INDEPENDENT ORBITER ASSESSMENT

ASSESSMENT OF THE FMEA/CIL INSTRUCTIONS AND GROUND RULES

14 OCTOBER 1986

WORKING PAPER NO. 1.0-WP-VA86001-01

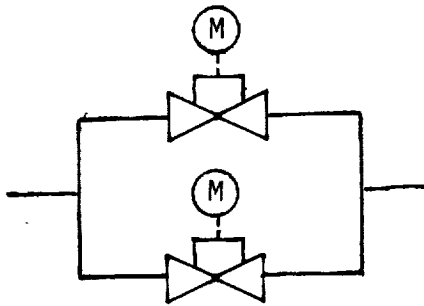
Problem: No provisions exist in Rockwell 100-2G to assure that FMEA/CIL identified failure modes are detected during ground turnaround. The Preliminary Draft of NSTS 22206 contained a provision to maintain a OMRSD matrix to track FMEA/CIL items against the OMRSD. Although the matrix was not adopted as part of the approved NSTS 22206, Basic, it will be maintained as an independent entity and will make reference to the FMEA/CIL identified items. In-flight verification of redundancy and the assurance that failure modes do not exist is at least as important as ground turnaround.

Recommendation: It is recommended that a matrix similar to the OMRSD matrix be adopted to provide tracability between in-flight checkout and critical items, to provide an awareness by both the crew and the ground in advance of potential problems.

Figure 3 - NSTS 22206 (Figure 1) FMEA/CIL Screening Process

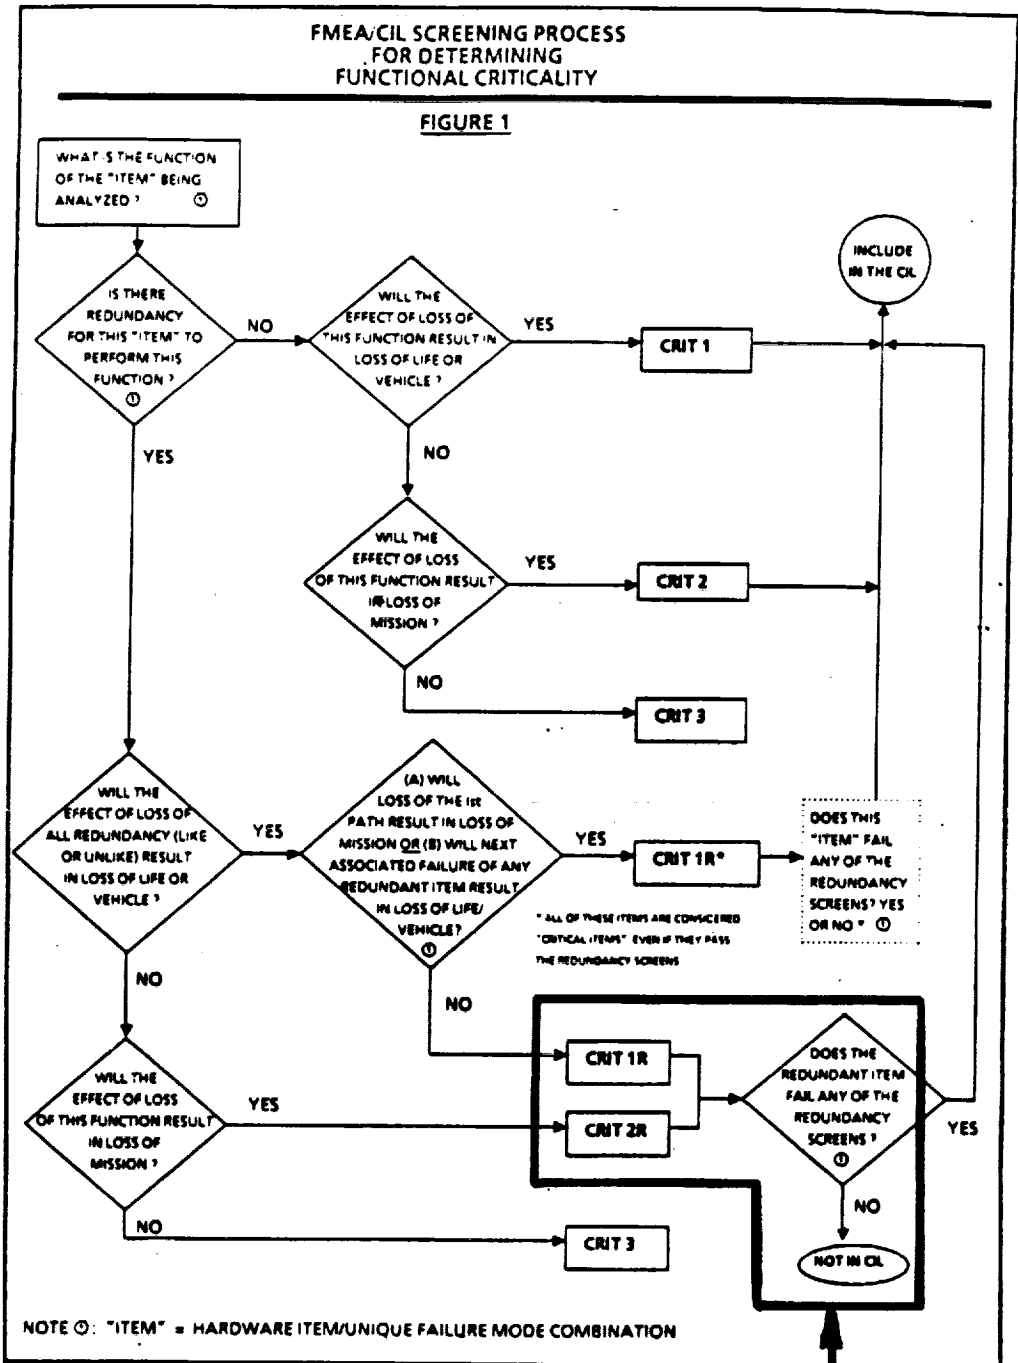
Problem: This figure is a logic road map for defining which orbiter items appear on the CIL. Two criticality categories are used: functional (which does not consider redundancy) and hardware (considers redundancy). Items that perform critical functions, but meet defined redundancy levels, and pass screens and are excluded from the Critical Items List (CIL). This exclusion creates a void in the control/assessment process. Attention and controls during manufacturing, assembly, test, failure reporting, corrective action review, and flight readiness reviews are less effective when all hardware that performs critical functions is not considered or treated. As a result, potential problems (latent manufacturing/design defects) with hardware may slip through the assessment process without management knowing the seriousness of the effects of failure.

Recommendation: Based on the Presidential Commission Report's position on management awareness, it is our recommendation that all automatic ground rules for excluding functional criticality 1R or 2R items from the CIL be eliminated and that, if items are to be eliminated, they be brought forward to the NSTS Program Level II change board for approval. In support of this position, it is recommended that the figure be replaced with a new figure shown as "Streamlined" replacement. Hardware criticality, in NSTS 22206 Figure 1, is replaced with a notation showing how many paths are available to accomplish the critical function.
